**Responses to NRC Questions Regarding Salem Bypass Testing During
Teleconference Held on November 28, 2012**

Figure 5-1: Penetration Velocity Distribution

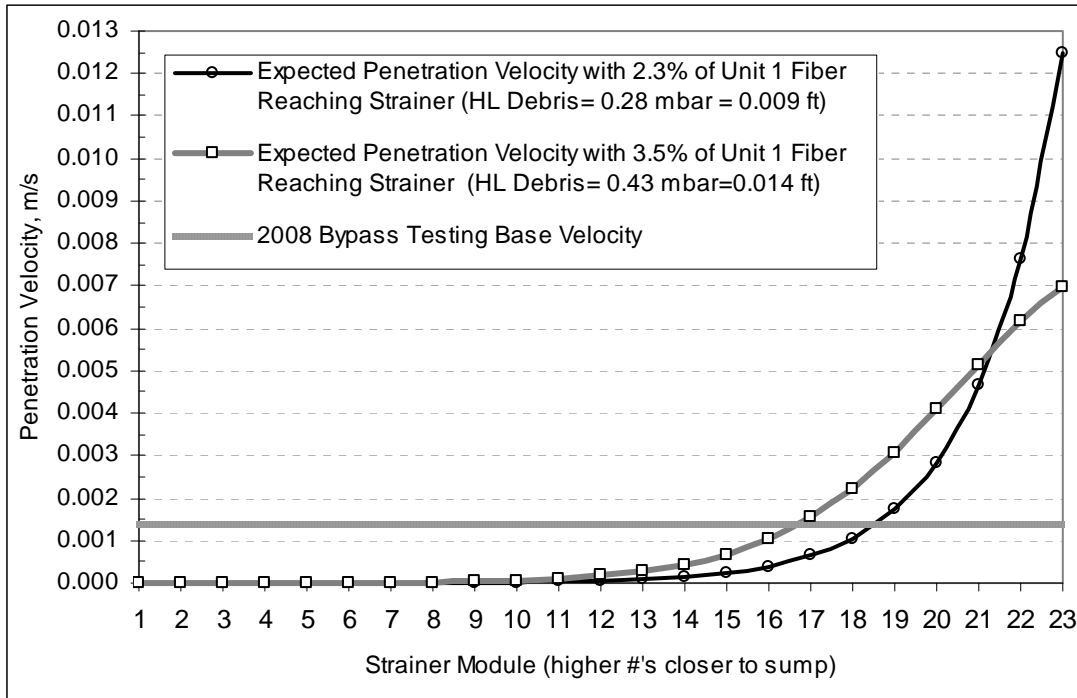
- 5) *The highest reported test velocities were about 80 times lower than the maximum expected velocity for the Salem strainer according to the vortex evaluation. How do velocity gradients of this magnitude affect bypass?*

To illustrate this point, a plot of the expected penetration velocities with approximately 2.3% (1/50" theoretical bed thickness) and 3.5% (1/32" theoretical bed thickness) of the Unit 1 fiber reaching the strainer is shown below (see question 18 for discussion on the ability of thin fiber beds to filter debris). Note, while the strainer and sump pit fill with water before recirculation begins, approximately 2.3% of the fiber will reach the strainer (based on the volume of water in the strainer compared to the volume of water in the sump pool at recirculation initiation assuming uniform debris concentration). The Unit 1 debris load is selected since it has a less uniform penetration velocity distribution due to a lower overall debris head loss than Unit 2 (see Section 3f.10.2 of 2012 Supplemental Response); however, the debris load is conservatively applied to the Unit 2 strainer since it has higher velocities. The plot of expected penetration velocity in each module was generated using the spreadsheets developed as part of the strainer head loss calculation (see Section 3f.9 of 2012

Supplemental Response). Based on a uniform debris concentration in the sump pool, two pump flow, and the strainer head loss being directly proportional to the quantity of debris on the strainer, it is expected that the penetration velocity profiles shown in the figure below would develop quickly after recirculation initiation.

As shown in Figure 5-1, it is expected that at recirculation initiation (when 2.3% of fiber is at strainer) approximately 75% of the strainer modules will experience penetration velocities lower than those tested in the 2008 CCI Bypass Tests. Furthermore, by the time 3.5% of the total Unit 1 fiber debris load has reached the strainer (approximately 25 seconds after recirculation begins), the penetration velocities at the modules nearest the sump are already significantly lower.

Non-uniform velocities could result in modules nearer the sump having a greater quantity of debris than modules farther from the sump due to the higher module approach velocities near the sump. The higher velocities could result in potentially more bypass in the modules near the sump. However, the results of bypass testing which give the mass of bypassed fibers per unit area based on a uniform debris bed/velocity show that additional fiber bypass does not occur beyond a saturation value which was reached during testing (See Question 6). Therefore, application of

Photo 10-1

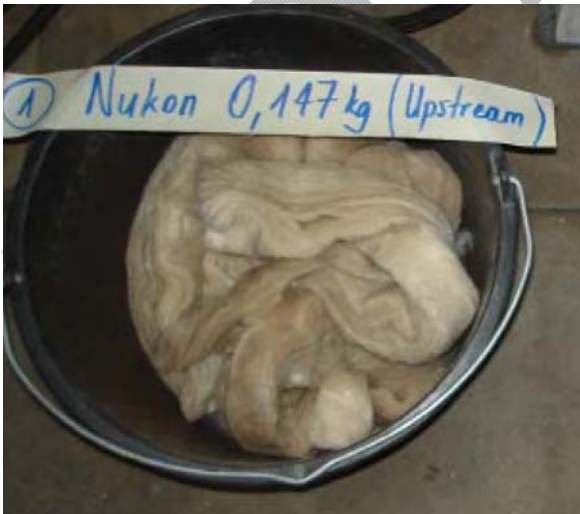
10) Discuss the procedures for debris control during the tests. How were the fibers ensured to all make it into the test tank after weighing and preparation?

The dry fiber material was weighed in separate buckets which were labeled with tape (see Photo 10-1 below). The dry material was then further divided into batches which were soaked with water prior to being blasted with a water jet. The fiber batches were placed in larger bucket(s) in order to accommodate water from the jet blasting. The quantity of debris in these larger buckets was also recorded and placed on a tape label on the bucket (red circle in Photo 10-2). The large buckets were not drained during the water jet blasting to ensure that no fiber fines were lost. The prepared fiber debris bucket was then placed on a scaffold near the MFTL and the fiber slurry was added to the test loop using the dip-bucket method where a pitcher was used to slowly add the debris to the MFTL (green circle in Photo 10-2).
